11767 HORROBIN FARM, TURTON

ICF APPROVAL DRAWING PACK

Issue P01 | 14.09.26

QUESTIONS FOR THE ENGINEER

EQ-01 CW13 marked L-18 (precast block lintel) on an ICF opening

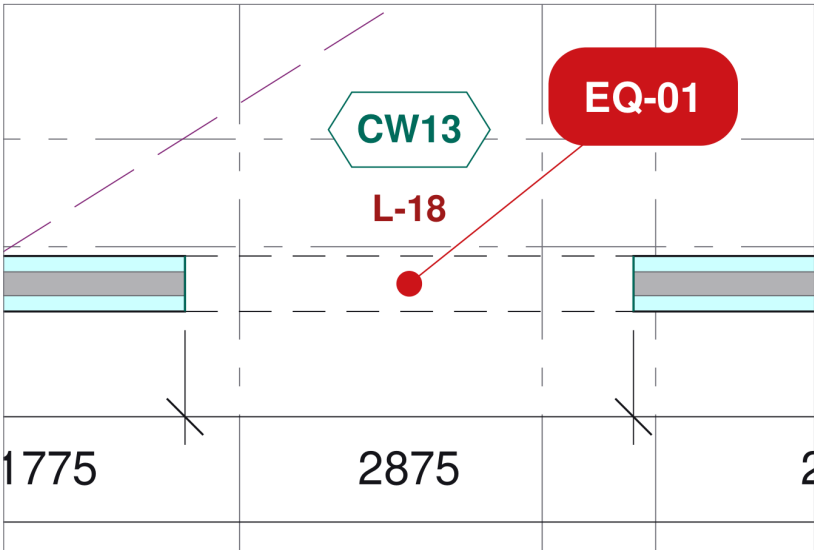
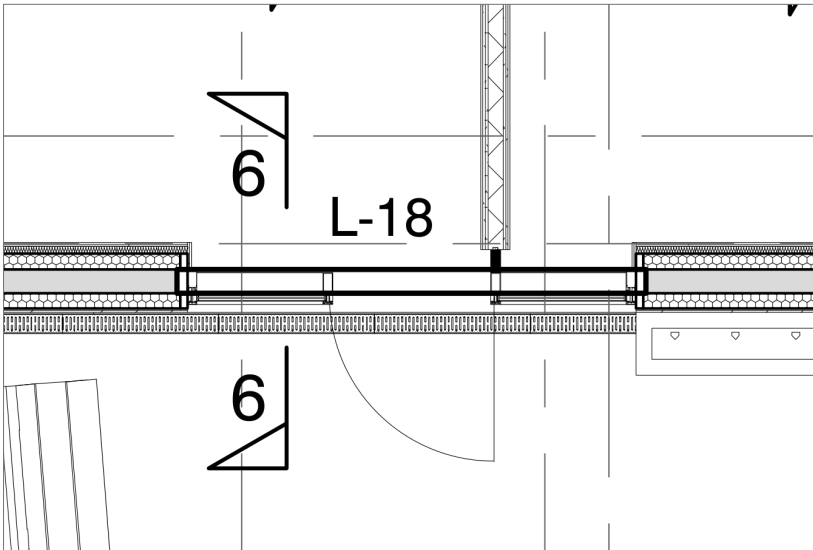
ISSUE CW13 (2875 wide, head +2400) is an opening in the external 150mm-core ICF wall. It is marked L-18, which the lintel schedule gives as a Naylor precast lintel R8 (140x215) / R7 (215x145) for 140/215 blockwork. The matching opening CW14 in the same wall is L-10 (300x150 RC, 2-H12 top / 2-H16 bott.).

QUESTION Please confirm the lintel for CW13: is L-18 intended, or should it be an RC lintel cast in the ICF core (e.g. as L-10)?

EQ-02 D1: steel B-6 as the head of the 5575 opening (confirm interpretation)

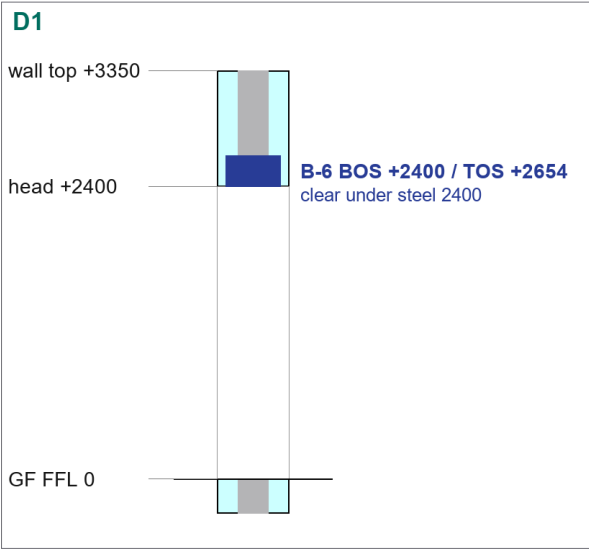
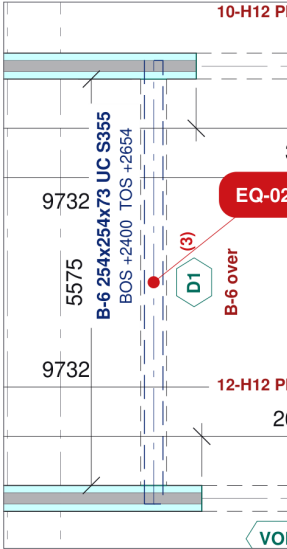
ISSUE D1 is the 5575 wide full-length opening in the ICF wall between the conservatory and the room to its east (Wall 21). Your drawing gives it no lintel mark and shows B-6 254x254x73 UC S355 (with 200x100x10 ledger angle one side) along that line. We have modelled B-6 at BOS +2400 / TOS +2654 as the head of the opening, with the structural opening in the ICF up to +2654 and ICF over the steel to the wall top at +3350, giving 2400 clear under the steel.

QUESTION Please confirm that B-6 forms the head of D1 as described (clear opening 2400 under B-6, ICF bearing on the steel above), or advise the intended arrangement.
